Subject: Hornsea Project Three - Registration Number 20010316 Oulton Parish Council/written submission of oral

Written submission of Oral representation from Susan Mather on behalf of Oulton Parish Council, including supporting information (Appendix 1 attachment)

OULTON PARISH COUNCIL: written submission of oral presentation at Deadline 10

Appendix 1

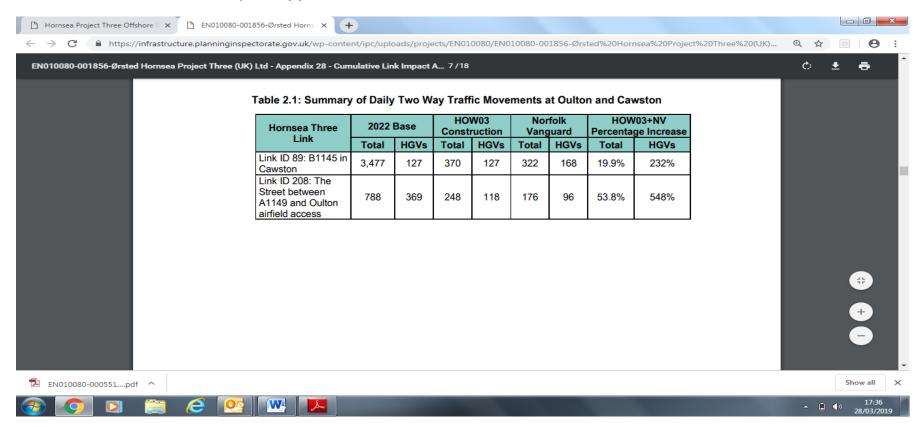
The Old Railway Gatehouse has been assessed for noise and vibration due to road traffic increases, especially HGVs. As a result of the noise and vibration assessment, a road intervention scheme has been proposed as mitigation to reduce potential noise impacts. It should also have been necessary to assess air quality at this property given the close proximity to the road and the increase in proposed HGVs.

OPC would maintain that it is unacceptable for the Applicant to consider that, because of the road intervention scheme introduced to mitigate noise and vibration effects at the Gatehouse, this should somehow obviate the need for an air quality assessment at the same time. The two issues are **entirely separate**, and the level of emissions caused by the increase in all traffic will need to be evaluated and mitigated separately.

Hornsea Three Cumulative impact Appendix 25 LINK 208 (LINK 68 last entry on the Table)

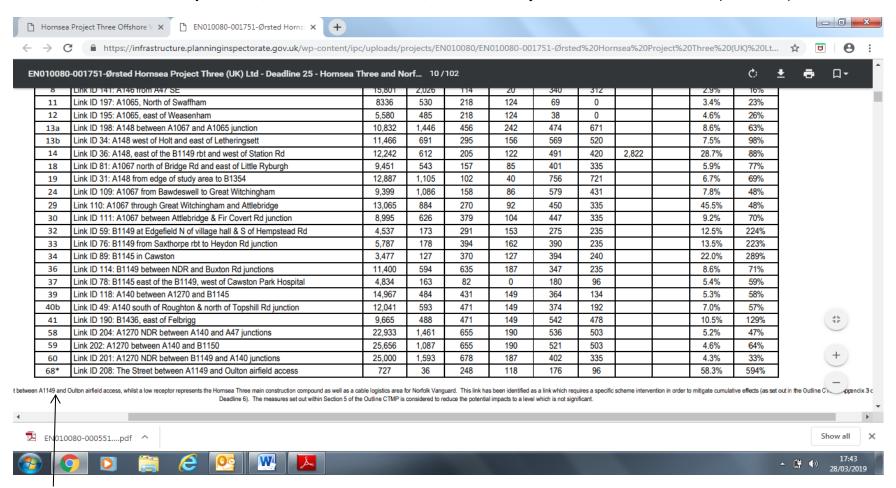
Hornsea Three cumulative impact Appendix 28 LINK 208

**Please note: Hornsea Project Three, in the documents below, has consistently mis-numbered the B1149 (Holt Road) as the A1149.
